## **DESIGN REVIEW BOARD**

June 15th, 2020

**986 SAVAGE RD.**  
TMS # 309-00-00-481

# NOVO LABS OFFICE BUILDING

NORTHWEST CURRENT

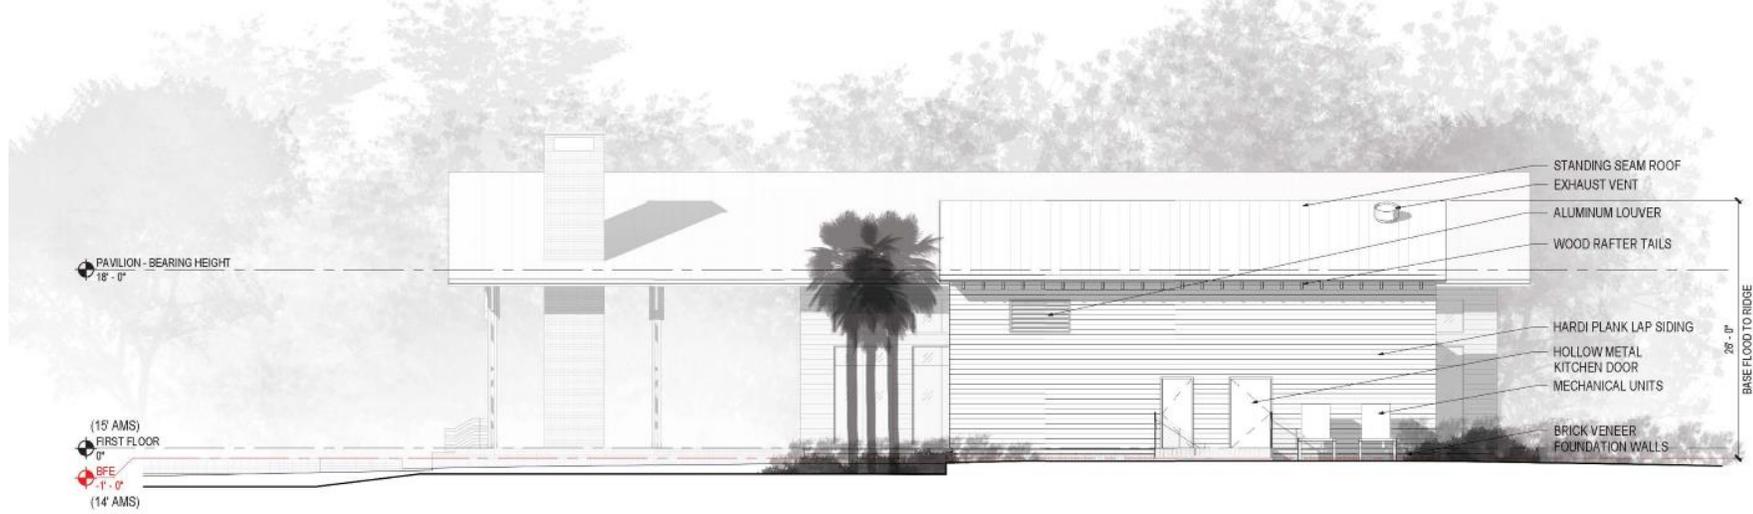
Elevation Changes:  
 Added gutter and rain chains to the gable roofs  
 Gutter at hyphen revised  
 Windows at Event Hall Revised  
 Mechanical Area Revised

NORTHEAST CURRENT

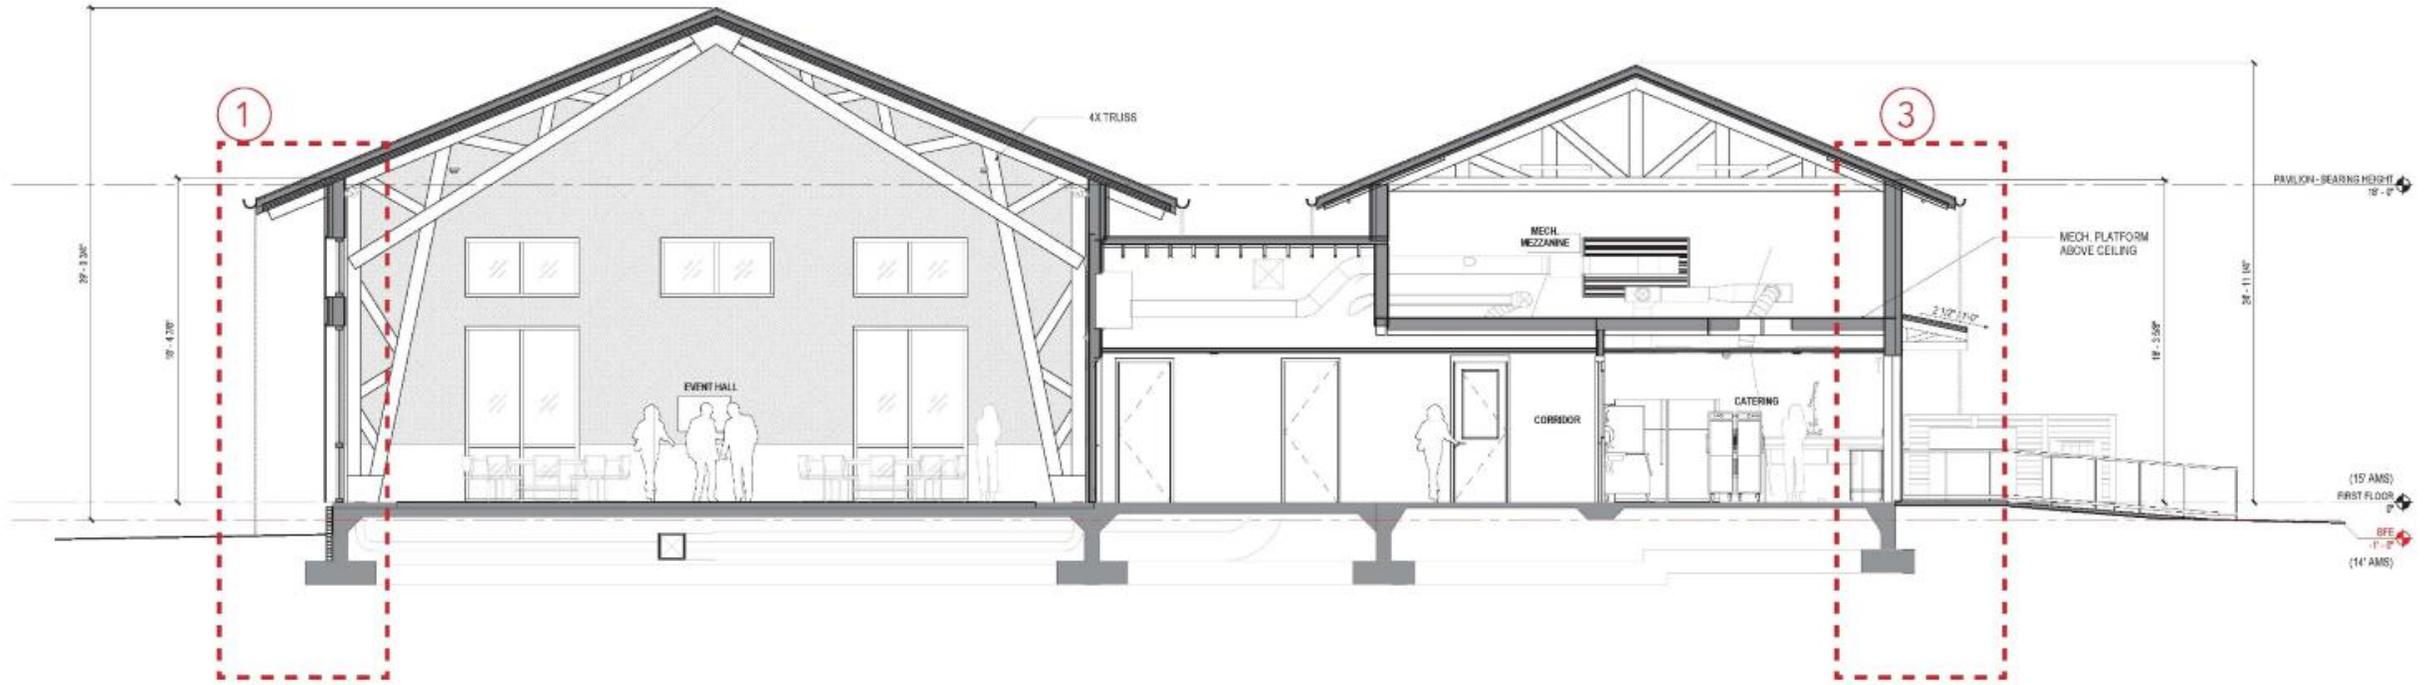
Elevation Changes:  
 Added gutter and rain chains to the gable roofs  
 Additional ramp and rail added  
 Service Entrance Revised

NORTHWEST  
CURRENT

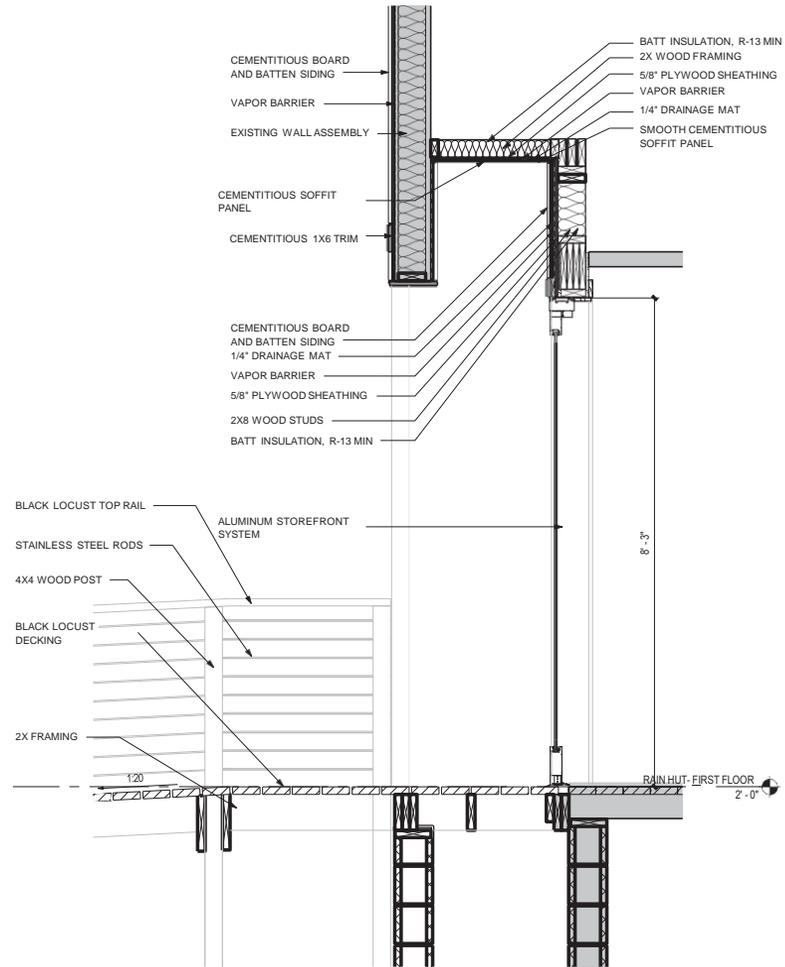
Elevation Changes:  
 Ramp rail design adjusted  
 Existing siding mis-represented as horizontal previously, vertical T1-11 is existing siding  
 Re-clad structure with Vertical Hardie Siding  
 Mechanical Screening refined

SOUTHEAST  
CURRENT

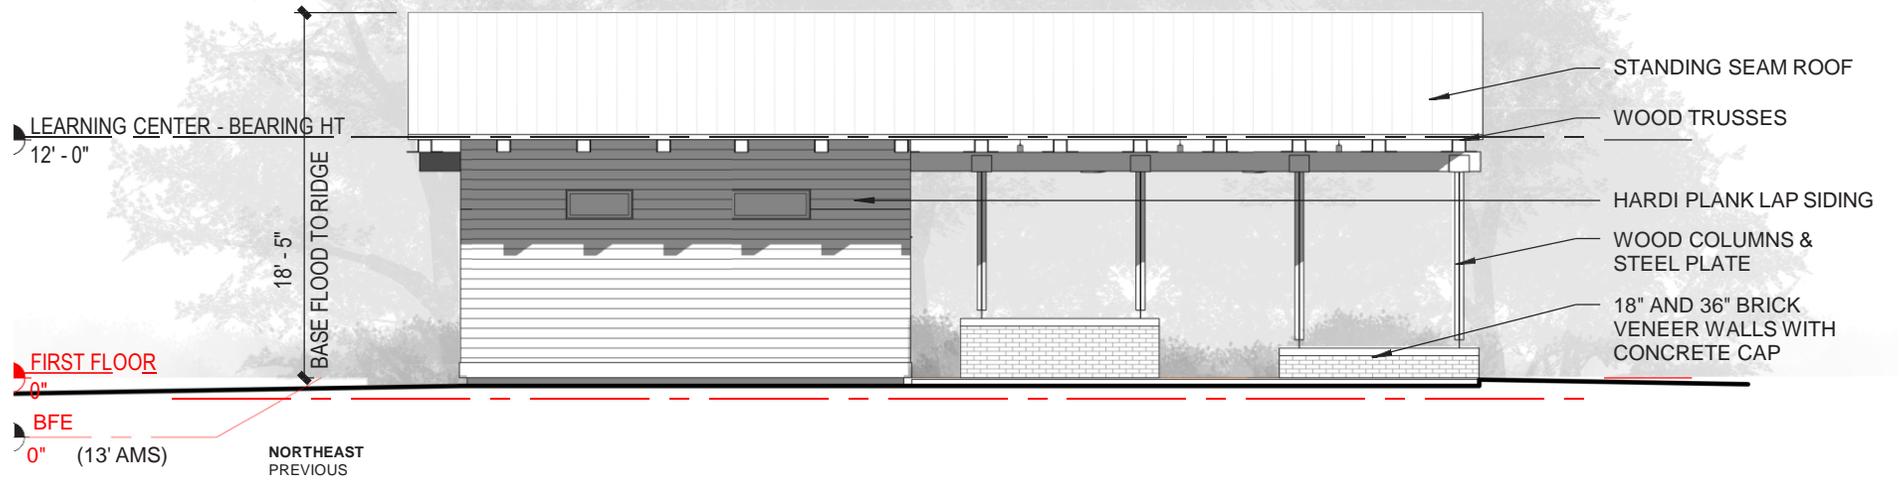
Elevation Changes:  
 Changed storage door  
 Reduced width of the brick walls  
 Moved mechanical louver to this elevation from NW  
 Changed roof to 5V

NORTHEAST CURRENT

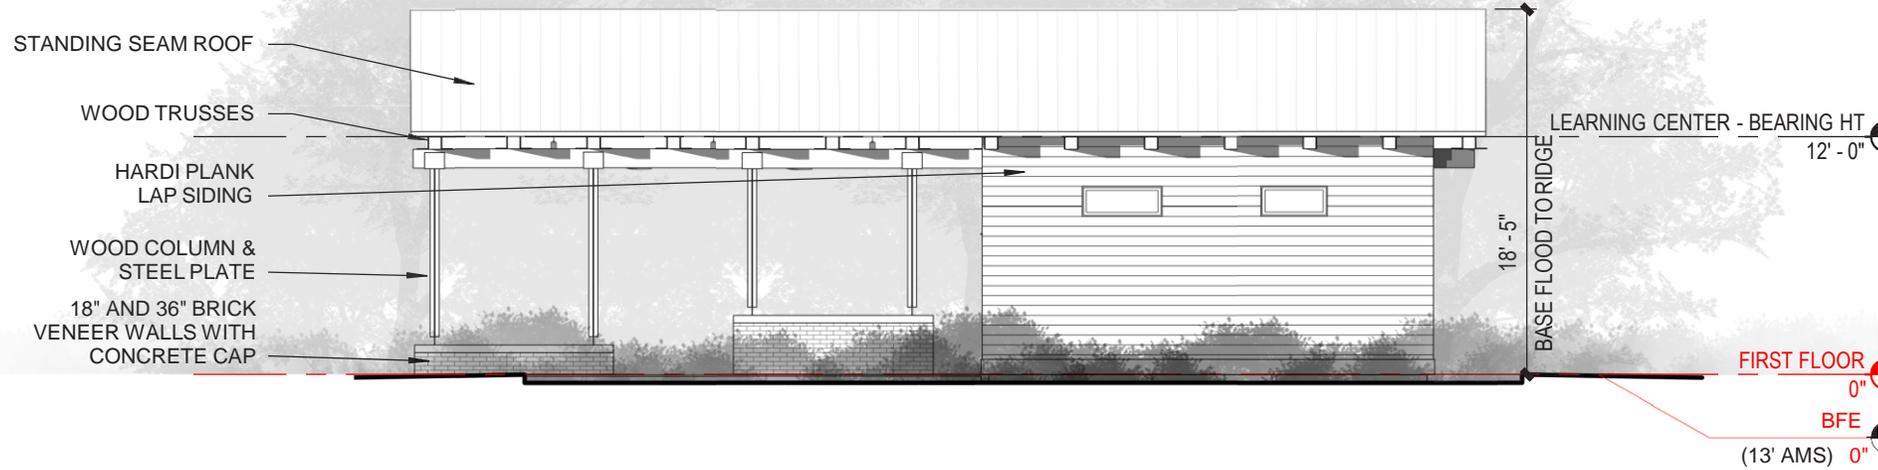
Elevation Changes:  
 Added sidewall vents  
 Changed roof to 5V Added gutter & rain chains

SOUTHWEST  
CURRENT

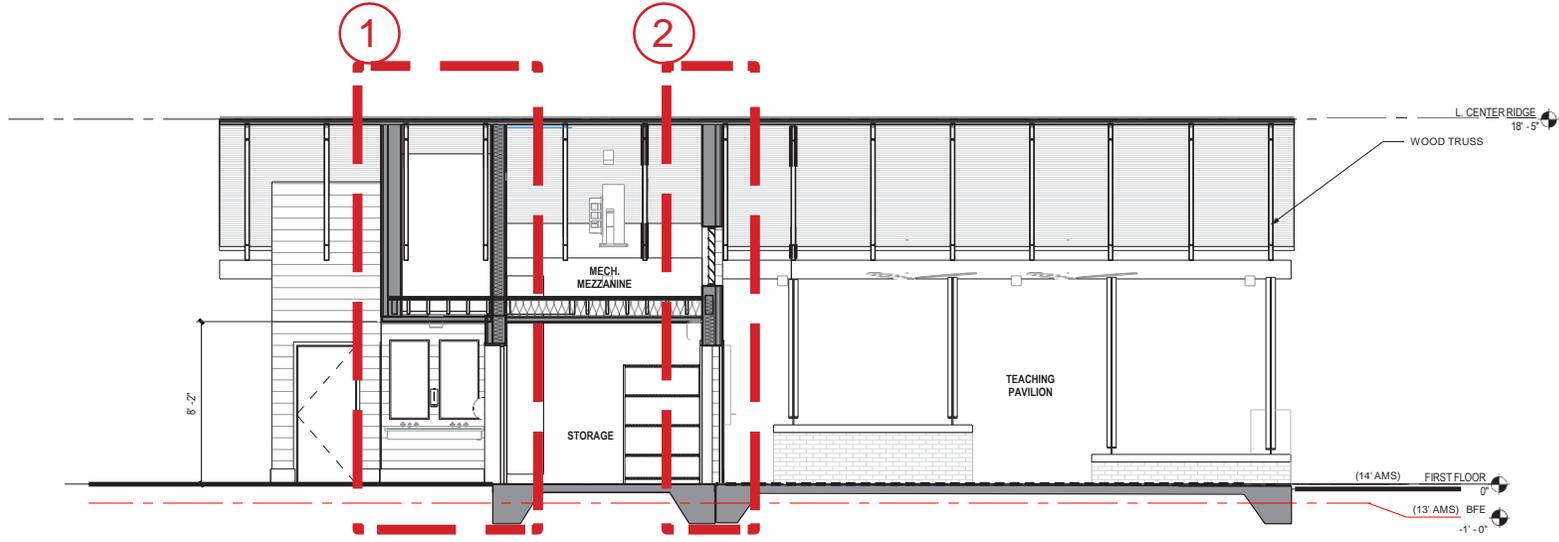
Elevation Changes:  
*Added sidewall vents  
 Changed roof to 5V  
 Added gutter & rain chains*
